100/300 AREA UNIT MANAGER MEETING ATTENDANCE AND DISTRIBUTION

Groundwater and Source Operable Units; Facility Deactivation, Decontamination, Decommission, and Demolition (D4); Interim Safe Storage (ISS); and Mission Completion

April 14, 2011

100-F-45 Verification Sample Design for the Excavation.

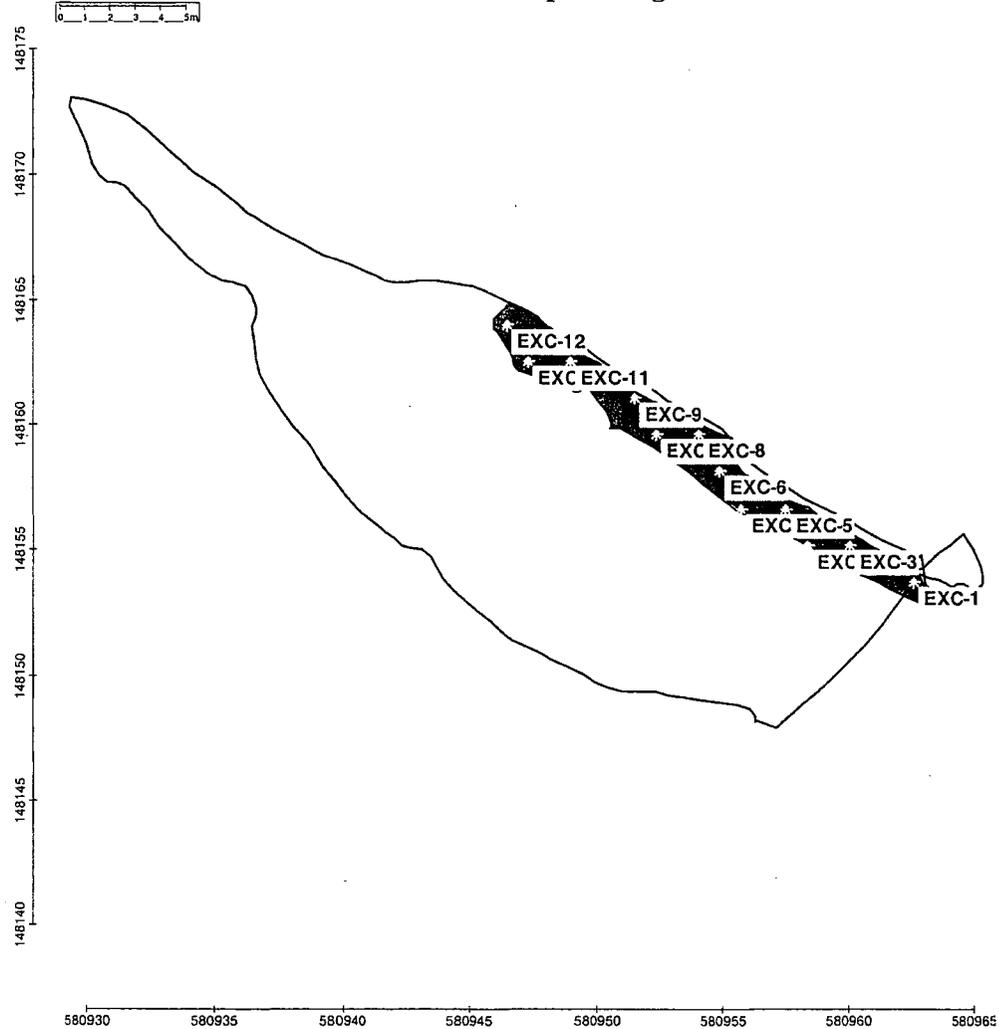
Chris/Tom, attached is a sample design we'd like to use for sampling the 100-F-45. We haven't gotten the final civil survey drawing of the excavation finalized, so Josh walked the disturbed area with a hand held GPS to depict the area of disturbance. The black line is the area that was disturbed to access the pipe and remove it. Although not real clear, the sample locations are in the bottom of the excavation and underneath where the pipe was located. They were laid in a random triangular shape that you should be familiar with as it's similar to other sample designs that have been approved in the past.

Agreement 1: Attachment 3 documents EPA approval to conduct sampling at 100-F-45 according to the associated sample design.

New potholes

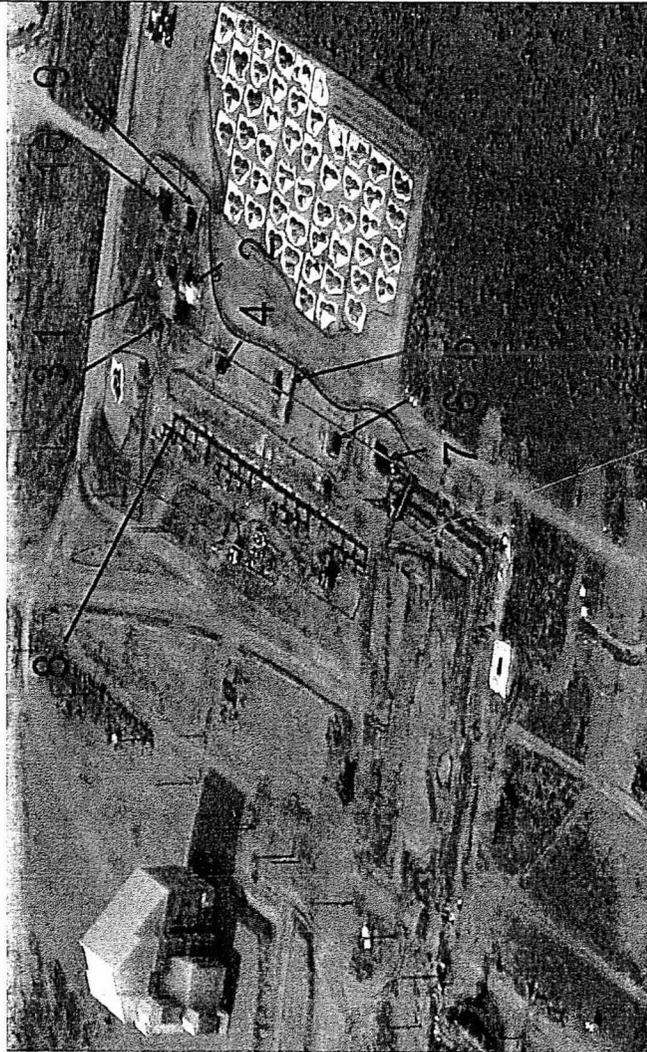
Remove and dispose of the 100-F-57 concrete slab and 2-ft of soil below the slab. To stabilize the ground prior to slab removal, clean fill will be placed into the potholes prior to slab removal. The amount of clean fill placed back into the potholes will be tracked and the locations of the potholes will be marked via GPS so that we will know the locations where the potholes were located. In addition, approximately 2-ft of soil will be removed to the northwest of the slab (potholes 1, 2, 3, 9, and 10 on PowerPoint drawing Mr. Fancher provided at Tuesday's meeting). WCH plans to initially backfill only potholes 1, 3, 9, and 10 at the northwest corner of the slab so additional sampling can be conducted at pothole 2 where visible staining on the side wall was identified (see additional discussion below) after which it will be backfilled with clean borrow. In addition, all the soil stockpiled on plastic from digging the potholes will be loaded out and disposed at ERDF.

It is understood that at some areas (pothole 2 & 8) Cr6 exists at over 2-ft deep that will require remediation. The initial removal of the slab plus 2-ft is the first step to allow remediation to commence quickly while further plans for excavation below 2-ft are finalized.

During this removal a new pothole will be dug west of pothole 8, another new pothole will be dug within the slab in the southeast area (south of pothole 7). Additionally, the visibly stained soil within the west wall of pothole #2 will be sampled at ~1-ft intervals (starting >2-ft deep) to the maximum depth (appx. 15-ft deep). The excavated soil will be stockpiled on plastic and disposed at ERDF once sample results are received. If backfilling of these new potholes becomes necessary, clean fill material from the 100-F borrow pit will be used.

Agreement 2: Attachment 4 documents EPA approval regarding a proposed plan and path forward for the chromium contamination encountered at 100-F-57.

100 D/DR AREA
BURIAL GROUNDS AND REMAINING SITES
OVERALL WASTE SITE LOCATION PLAN

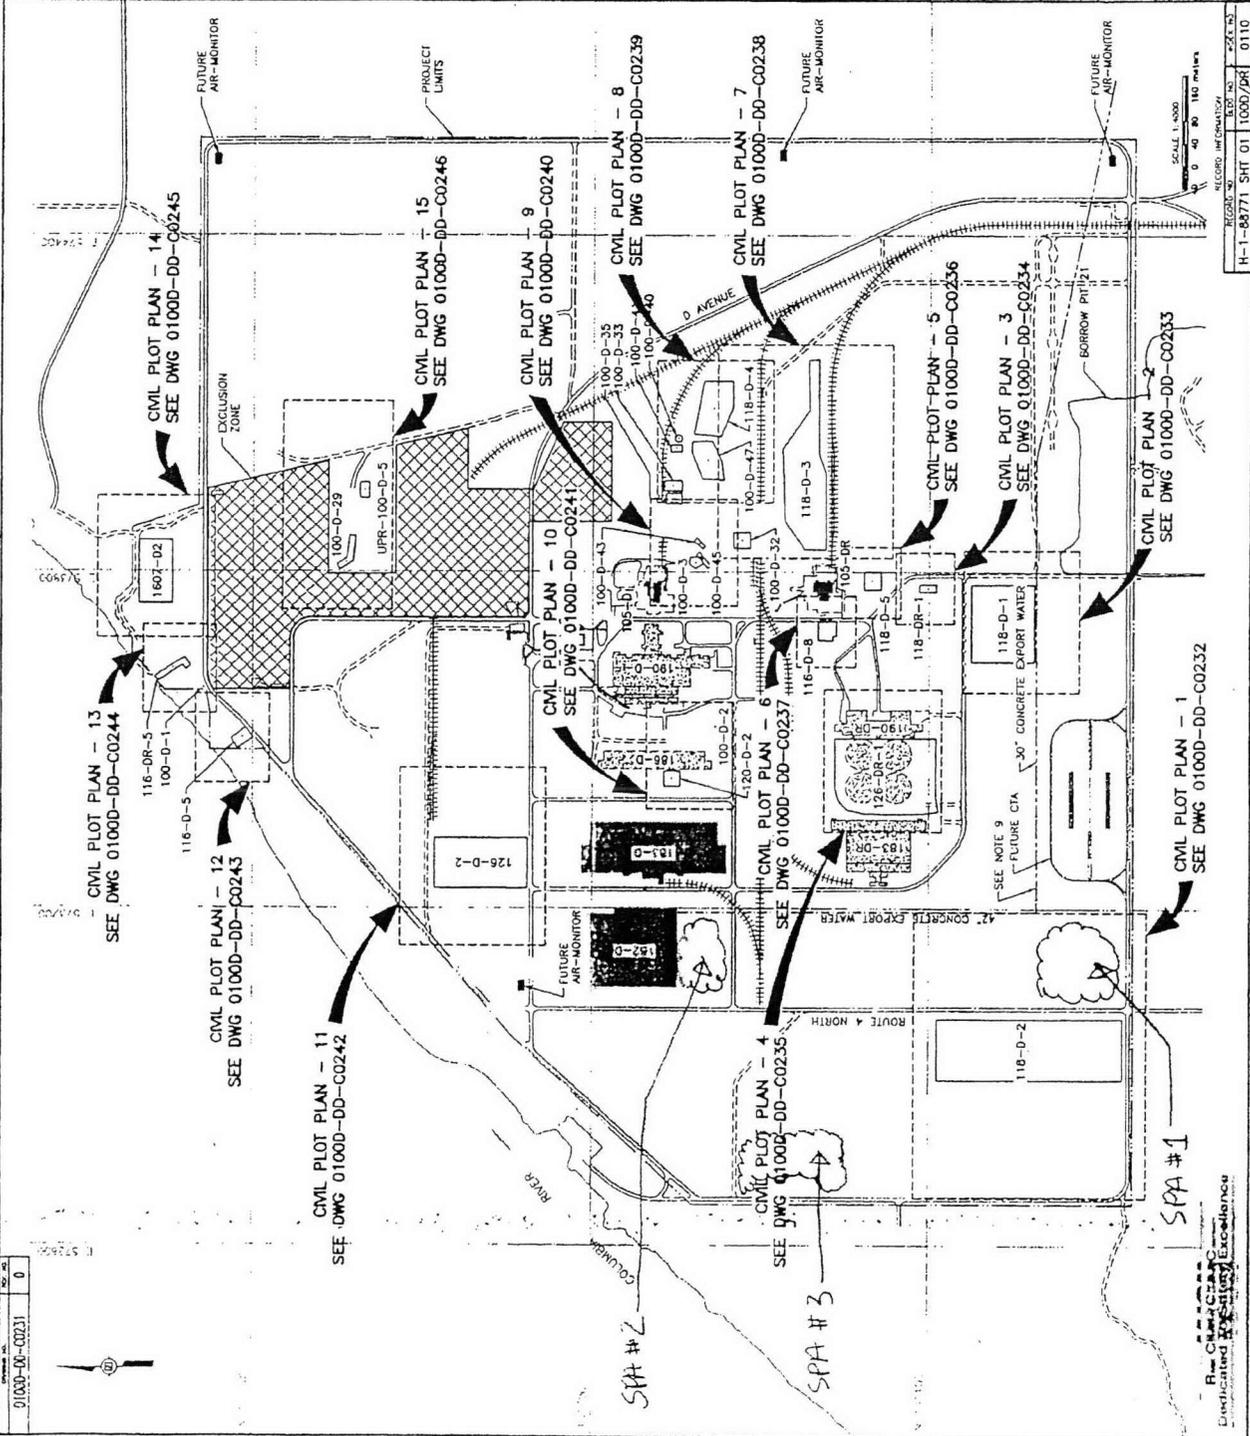
Thanks for all the clarification remarks concerning your request to add the three additional stockpile locations (SPA #1-3) indicated on the map Julian provided. Ecology approves these sites for temporary stockpile use in support of 100-D-50:6 and the high-priority chrome sites cleanup activities.

Agreement 1: Attachment 5 documents Ecology approval to add three additional stockpile locations in support of 100-D-50:6 and the high-priority chrome sites cleanup activities

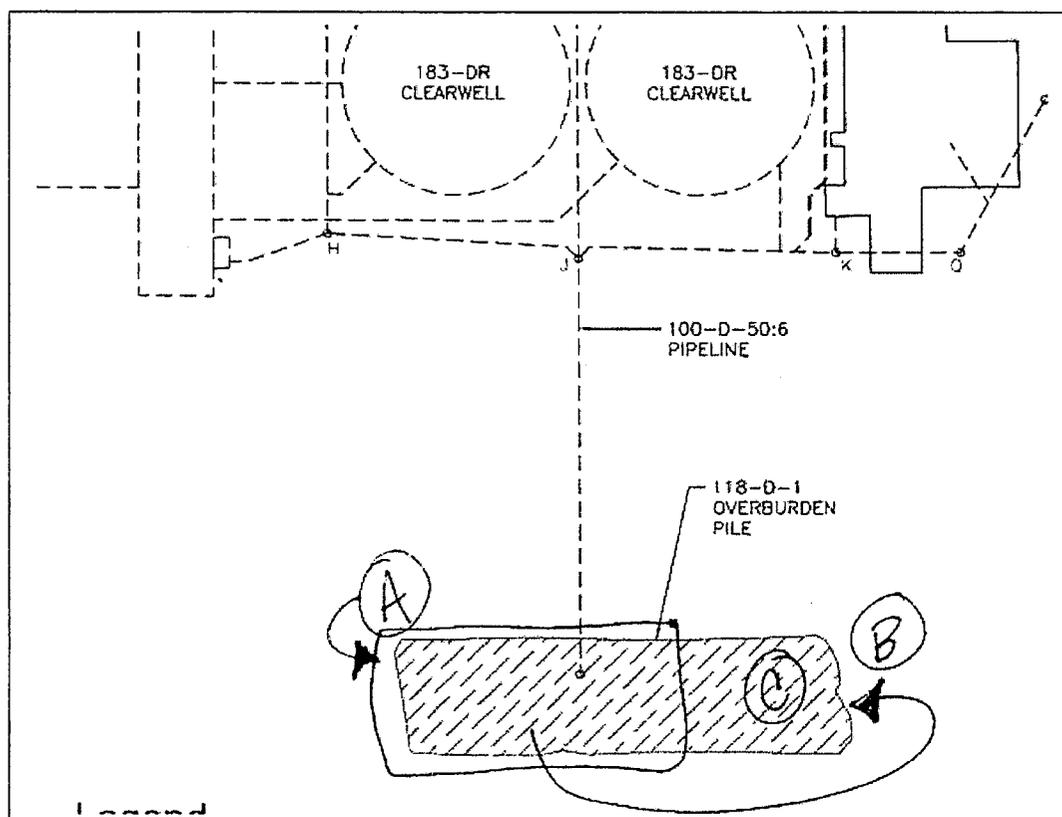
Remediation has started on the 100-D-50:6 pipeline subsite. A portion of the 118-D-1 overburden soil stockpile is located on top of the southern most section of the 100-D-50:6 pipeline subsite. A request is being made to relocate the overburden soil stockpile to provide access to the pipeline subsite for removal. The request includes two options.

- Relocate a portion of the overburden soil stockpile (marked A on figure) to the east end of the stockpile (marked B on figure), or place it on top of the east end of the stockpile (marked C on figure).
- Backfill the 118-D-1 sorting cells using the overburden material. This would provide the Field Remediation project additional area to stockpile the 100-D-50:6 material.

Per the attachment provided, Ecology sees no problem with the overburden pile being used to backfill the 118-D-1 sorting cells. This would provide WCH with additional stockpile area, and reduce moving the material more than necessary.
